## Valve Stem Extension Contacting Outer Wheel

Published August 2023

VNL, VNR, VNX, VHD, VAH manufactured from 1 January 2018 to 1 October 2023

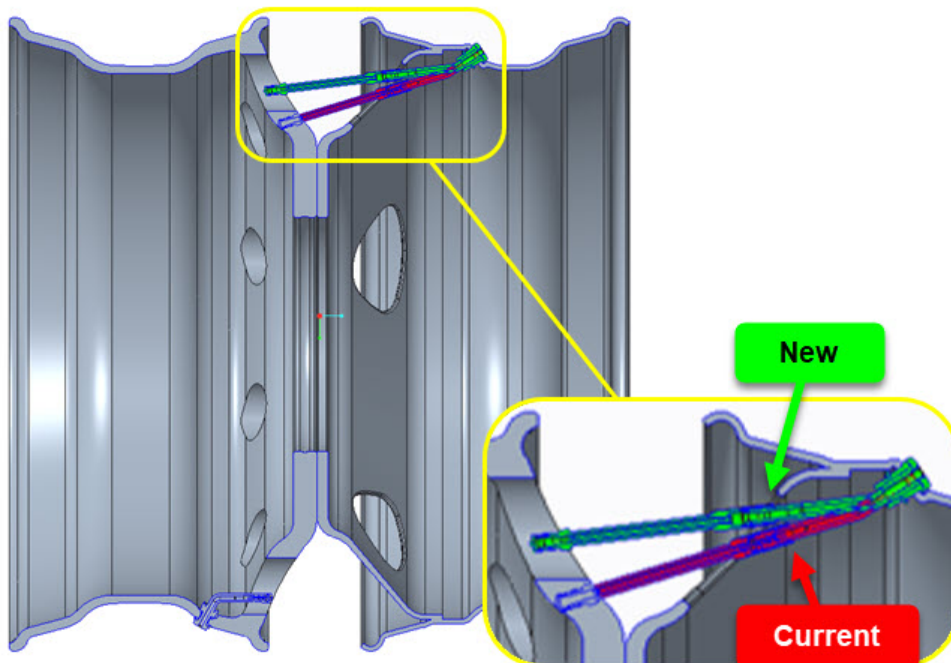
For vehicles with certain 22.5" or 24.5" wheels, the inner valve stem extension on the rear wheels may contact the outer wheel.

For affected vehicles, a new inner valve stem is being introduced that moves the valve stem extension to the center of the corresponding hole in the outer wheel.

Old Part #	New Part #s (Either new part can be used to replace old #s)
23805135	23805131, 22504862
22276620	23805131, 22504862
